JC ENGINEERING, INC.

February 9, 2024

RE: Responses to Initial and Technical Peer Reviews as prepared by Allen & Major, Inc.
Hidden Trails Definitive Subdivision Plan

Comments from A&M are shown in italics followed by responses from JCE. Also attached is the revised Definitive Subdivision Plan of Hidden Trail, dated 2/9/24 (Plan) and a revised Stormwater Report, dated 2/9/24 for review.

**Contributing Drainage Areas to
Potential Vernal Pool
Hidden Trails, W. Warham, MA**

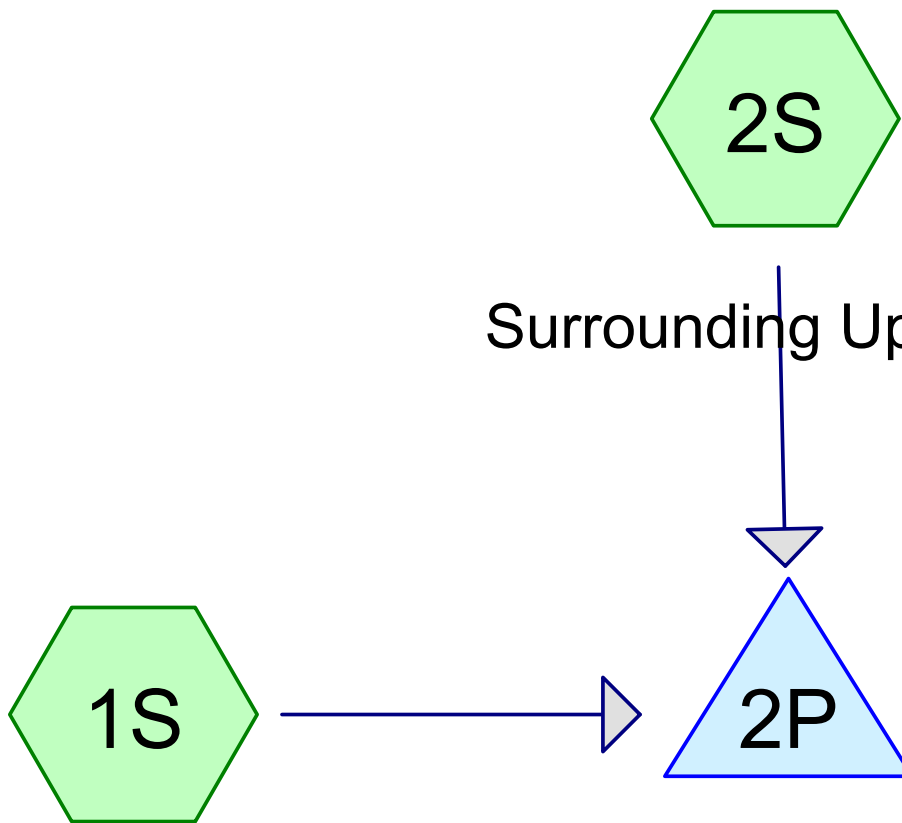
- *Flags present: A1 to A7 (LEC agrees with flag locations).*
- *Note: this IVW is a NHESP mapped Potential Vernal Pool (PVP) according to MassGIS. Wareham's Wetland Bylaw protects vernal pools and the 100-foot Buffer Zone regardless of whether the site has been certified by the Massachusetts Division of Fisheries and Wildlife. If this PVP is determined to be certifiable, it may affect permitting as the proposed*

stormwater infiltration basin is within the 100-foot Buffer Zone. The applicant should provide documentation as to the intent of work adjacent to this resource area.

JCE concurs that this IVW is mapped as a potential vernal pool (PVP). Although JCE has not determined whether this IVW is a vernal pool or not, JCE has calculated the boundary of this PVP in accordance with the State Wetlands Protection Regulations, 310 CMR 10.57(2)(b)6 and has depicted the boundary on the Plan. A drainage area sketch and HydroCAD analysis is attached to this letter. Further, the Wareham Wetland Protection Bylaw defines a vernal pool to include the area within 100 feet of the mean annual boundaries of such depressions which is also depicted on the Plan. The boundary of the local PVP is approximately the same as the 100-foot buffer zone to the IVW. The location of Infiltration Basin #1 has been relocated to provide a minimum 30-foot buffer to the local PVP, but is now outside of jurisdiction from the IVW. Also, proposed Lots #1 and #2 have also been relocated to the northerly side of the right of way to ensure that future lot development will not take place within the 100-foot buffer zone to the local PVP boundary. We note that site conditions have not changed since the issuance of the Order of Conditions for the prior development, which classified this resource area as only an IVW.
